D E S I G N
R E V I E W
C O M M I T T E E
S T A F F R E P O R T

1820 San Pablo Avenue

PRELIMINARY DESIGN REVIEW

Design Review #DRCP2021-0017 to demolish the existing commercial building and construct a four-story, 42,831-square-foot, 44-unit, mixed-use building, with 6,364 square feet of commercial area.

B CONCEPTUAL LANDSCAPE PLAN: PODIUM COURTYARD
1/16"=1'-0" NORTH

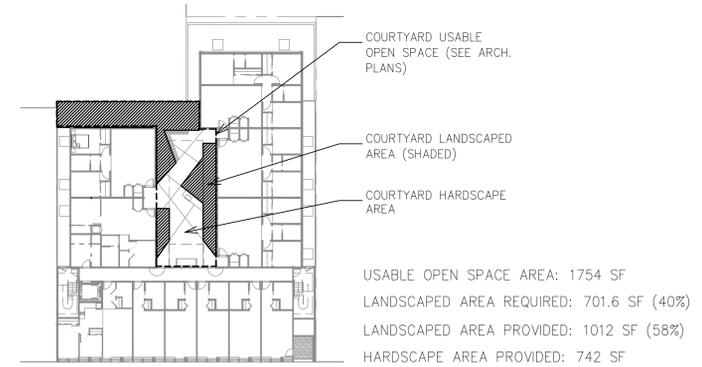
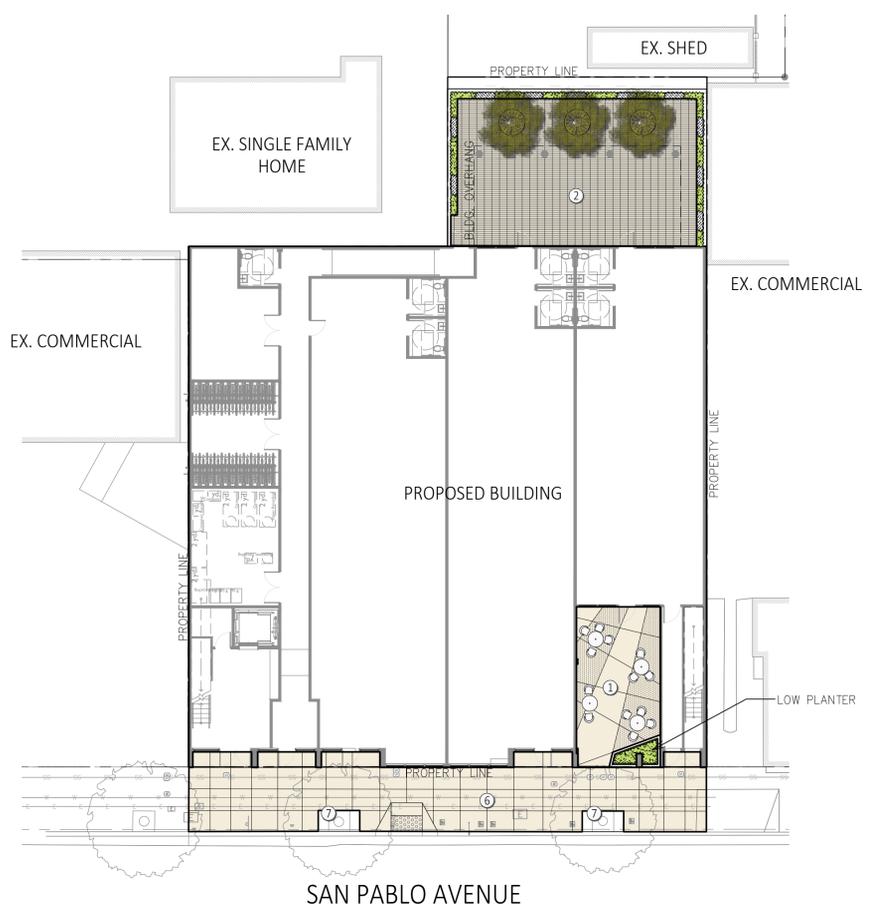
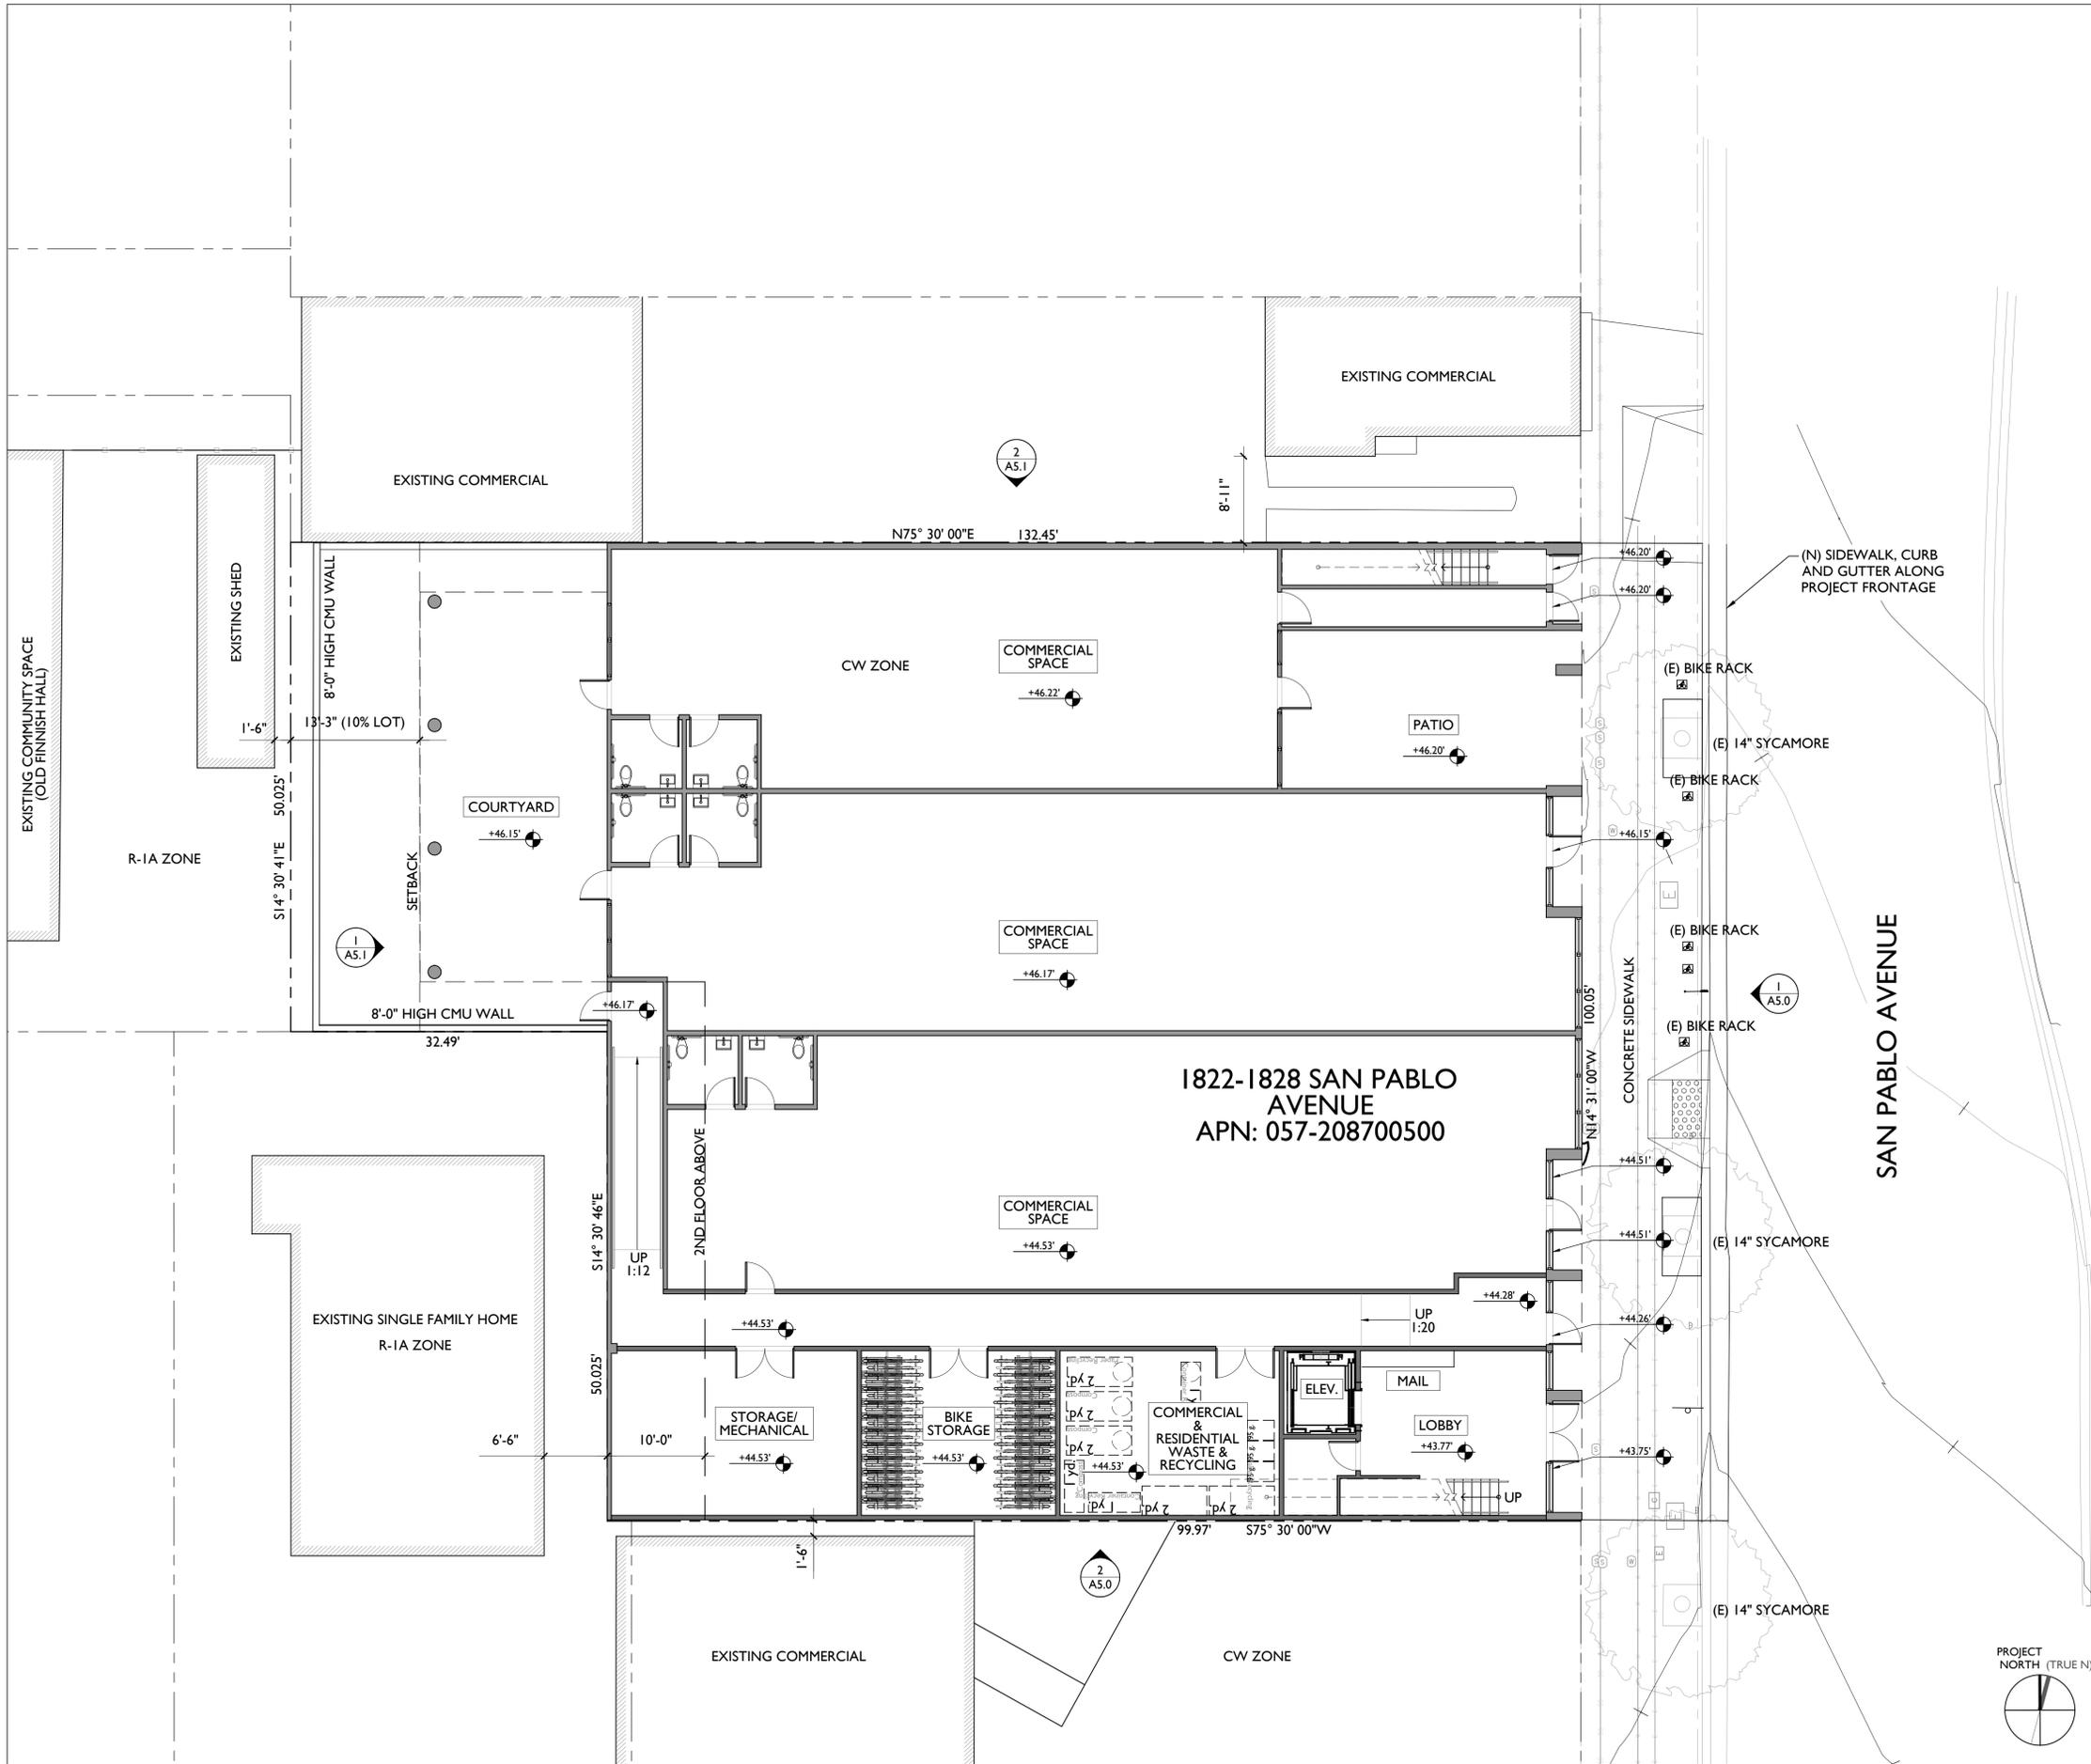
- *Need to provide adequate open space. Show more details how this is possible, even with the narrow courtyard space.*
- *Front commercial courtyard could be dark in the afternoons. Look at eliminating the closed corridor adjacent to the commercial entry courtyard.*
- *Resolve privacy issues for units facing the podium open space.*
- *Resolve any acoustic design and sound management issues with the rear commercial seating area that impact adjacent parcels.*
- *Recommend more native plants.*
- *Recommend permeable pavers where possible.*

15	Recommend more native plants.	Additional native plants have been provided.
16	Recommend permeable pavers where possible.	Permeable pavers have been noted at rear court.

- Landscaping in the courtyard has been reconfigured to allow for greater useable space.
- Planters in the courtyard have been laid out to afford privacy to the adjacent units.
- Plant palette has been updated to include more native plants.

**PROPOSED -
FIRST FLOOR
PLAN**

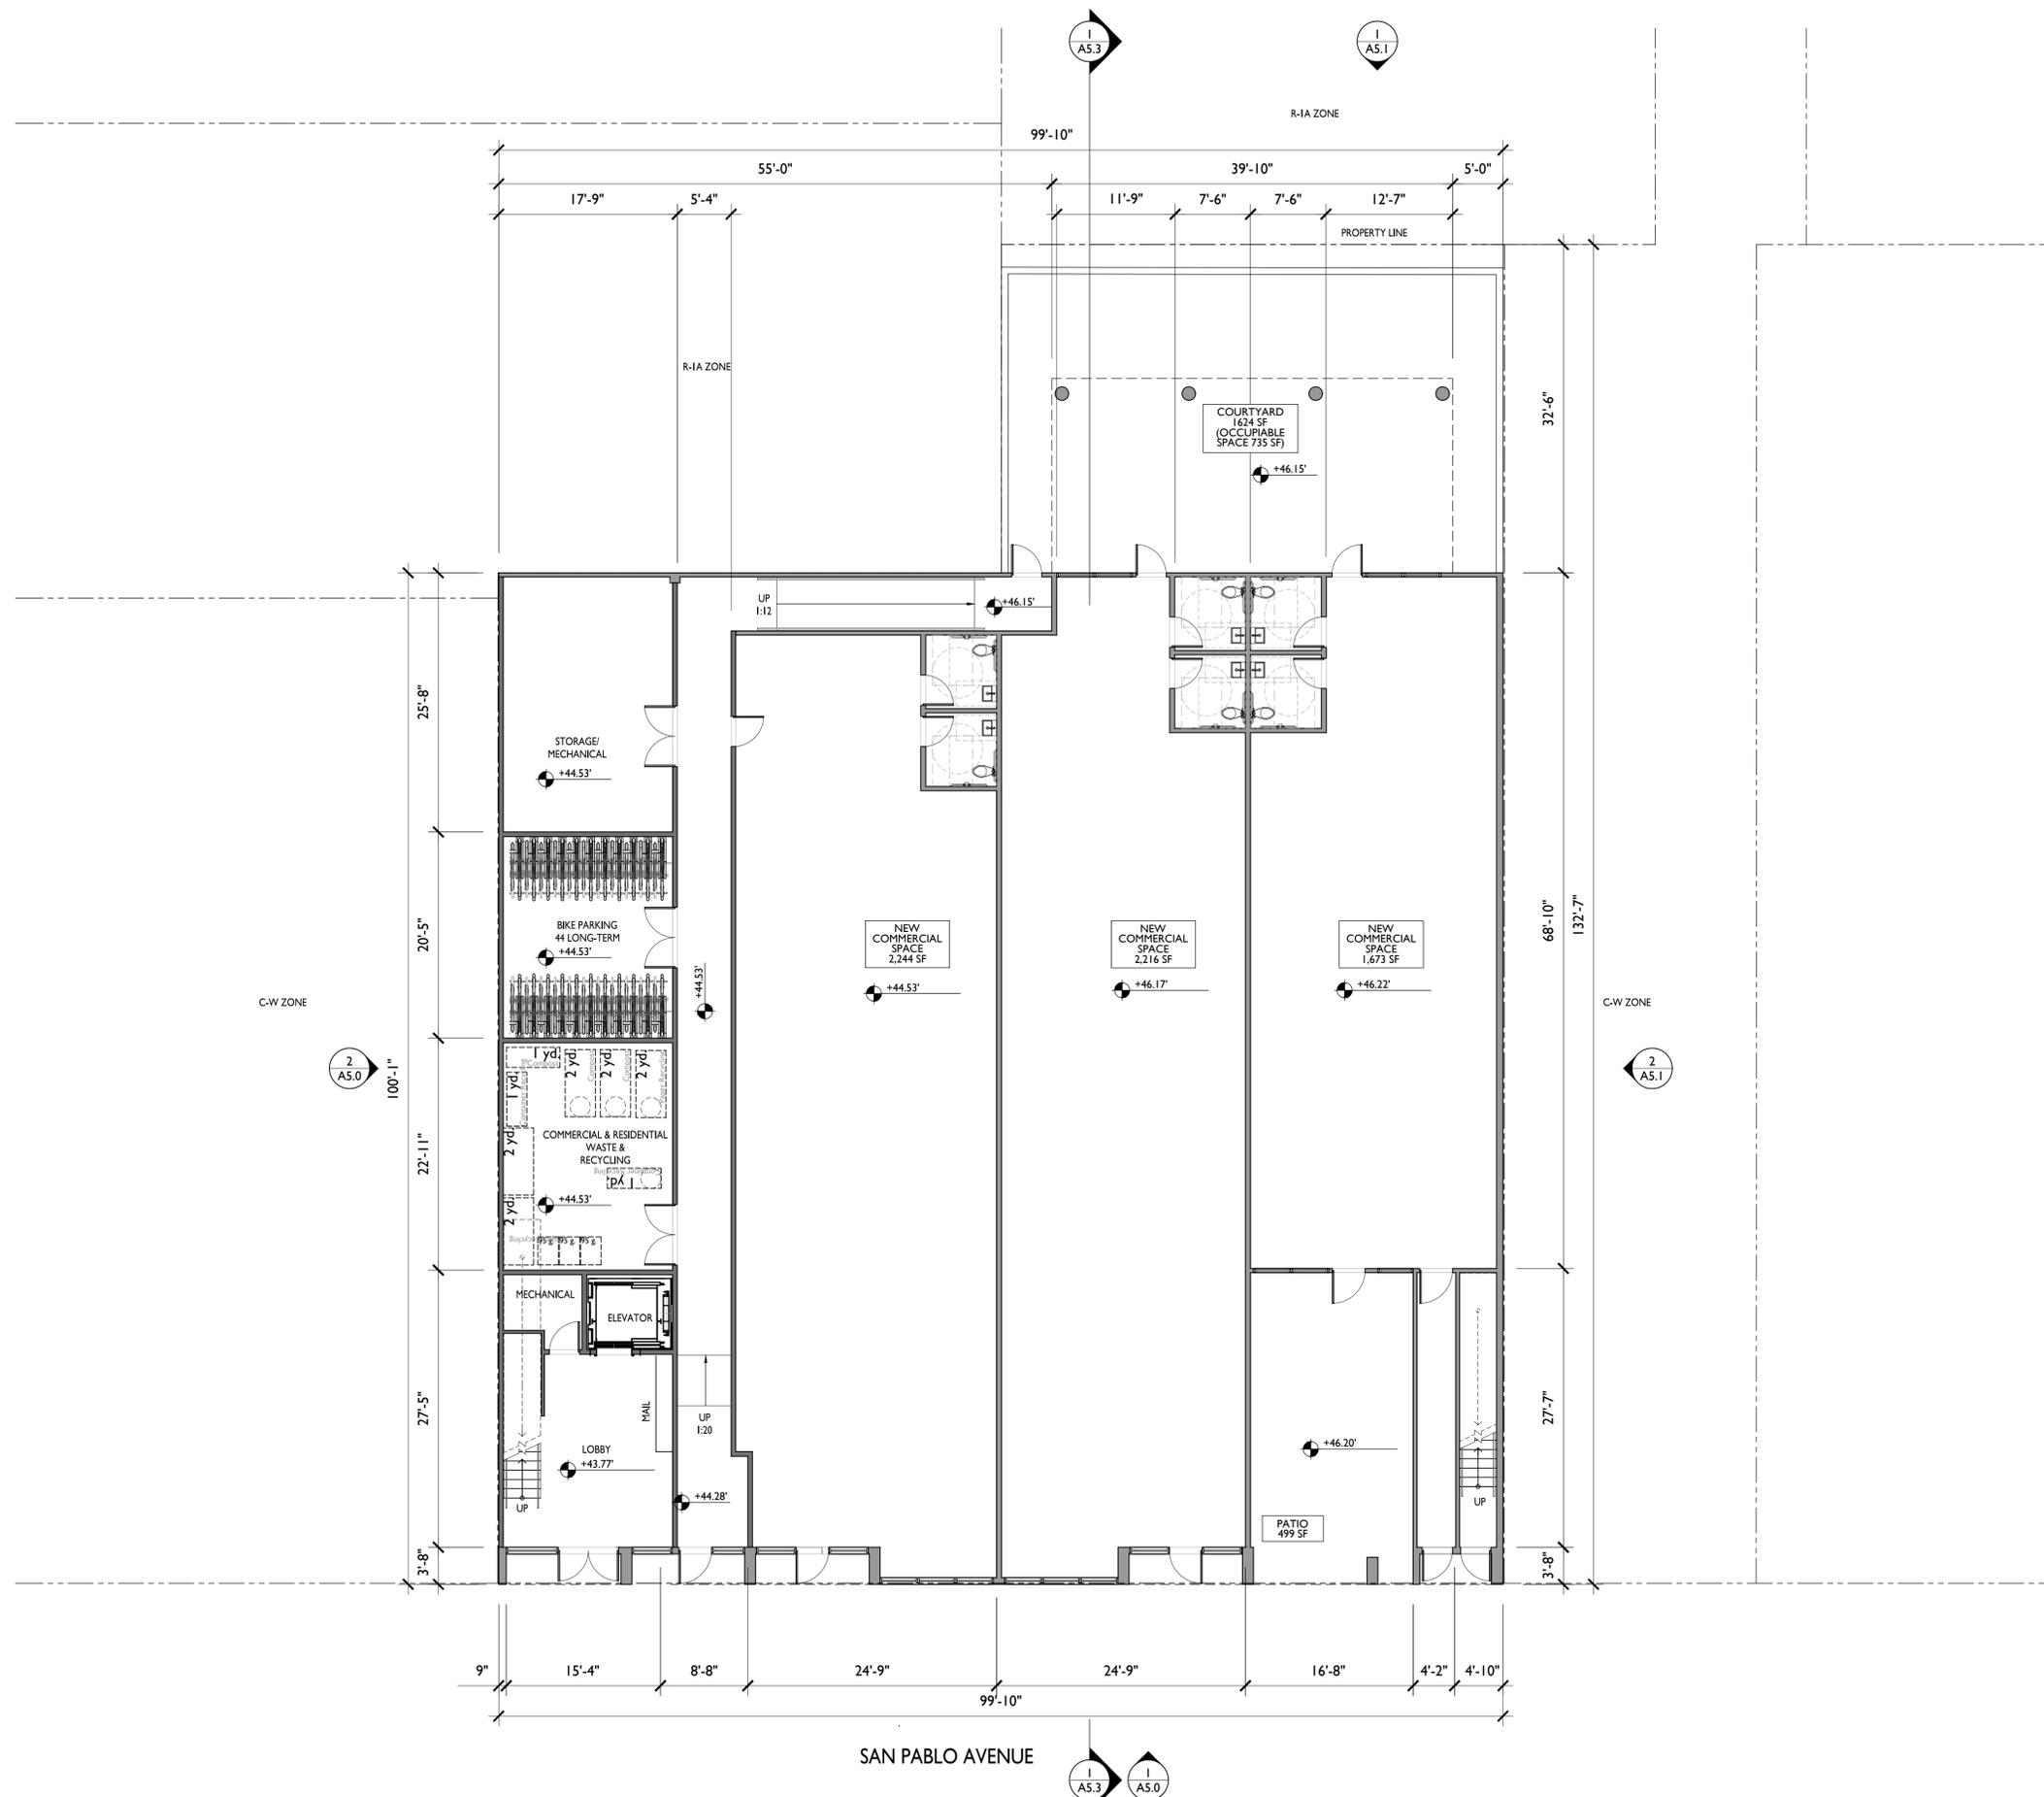
10	Relocate bike and trash rooms off of San Pablo elevation, so more commercial could be on this frontage	Bike parking and trash room have been moved behind lobby and commercial frontage has increased accordingly.
Landscape / Open Space Design	11	Need to provide adequate open space. Show more details how this is possible, even with the narrow courtyard space.	Courtyard landscaping has been moved to perimeter to create large open space along center of courtyard.

- All windows have been recessed per Committee recommendation with additional fenestration detail added to transom windows.
- Awnings have been added over the storefronts
- Lobby has been enlarged. Bike and trash rooms have been relocated behind the lobby to allow for an increase in the commercial frontage.

PROPOSED - ELEVATIONS

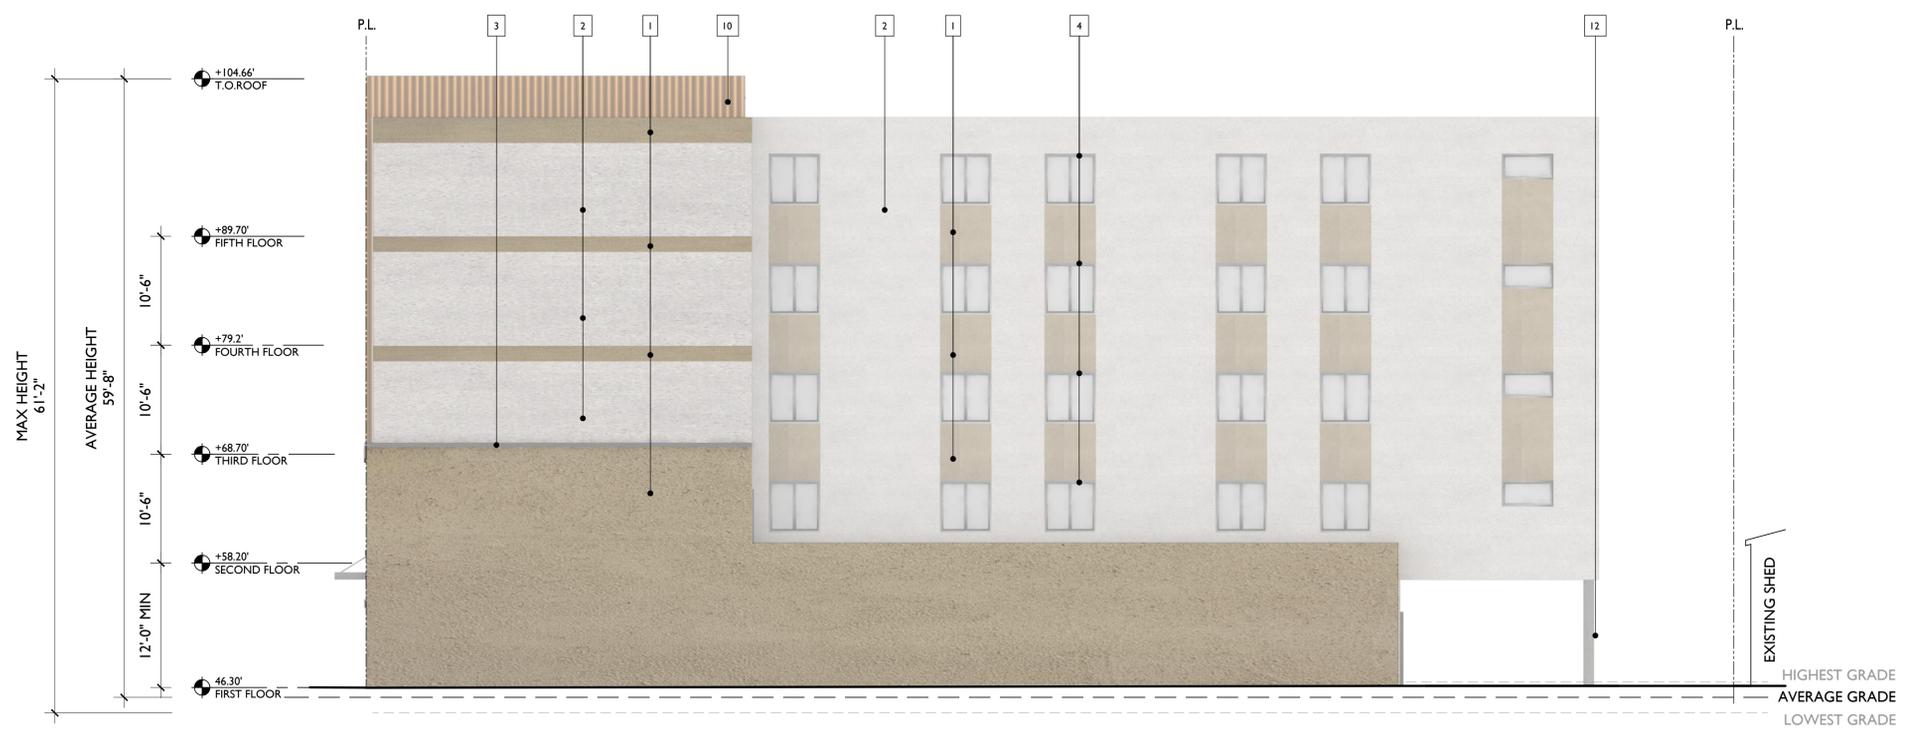
- *Bay design is overwhelming. Further refine design so bays are more in balance with the overall building design. Consider vertical proportions and more glazing in between bays, as well as more variety in bay design.*
- *San Pablo façade appears to be too institutional.*
- *Simplify colors on upper floors, but consider adding more color on San Pablo with the bays.*
- *Unfinished wood siding is a concern. Provide an alternate material or detailed maintenance information.*
- *Show more building details, including bays, railings, and ground floor storefront design.*

2	San Pablo façade appears to be too institutional.	All windows have been recessed to provide more depth. A second accent color has been added to the first two floors for a less monolithic appearance. Additional mullions have been added to the transom windows and awnings have been added over the ground floor storefronts. The bike parking and trash room have been moved behind the lobby increasing the active retail area along the façade. As mentioned above, the upper bays are now differentiated enough to provide a more playful appearance.
	3	Simplify colors on upper floors, but consider adding more color on San Pablo with the bays.	North bay has been changed from natural wood to corrugated metal with tones that are complimentary to but different from those of south bay. A second accent color has been added to the first two floors for a less monolithic appearance.
	4	Unfinished wood siding is a concern. Provide an alternate material or detailed maintenance information.	Unfinished wood has been removed and replaced with Kynar-coated corrugated metal siding.

- Bays have been further developed so that each have distinct characteristics. The proportions of the Northernmost bay has been revised for more verticality and still has a different finish than the Southernmost bay. Now there is more glazing in between the two bays.
- More clear glazing has been added between the two bays on the East façade.

- Natural wood has been removed and replaced with corrugated metal panel.
- Southernmost Bay now features a grid of light and dark Parklex panels while the Northernmost Bay is clad with two corrugated-metal colors.
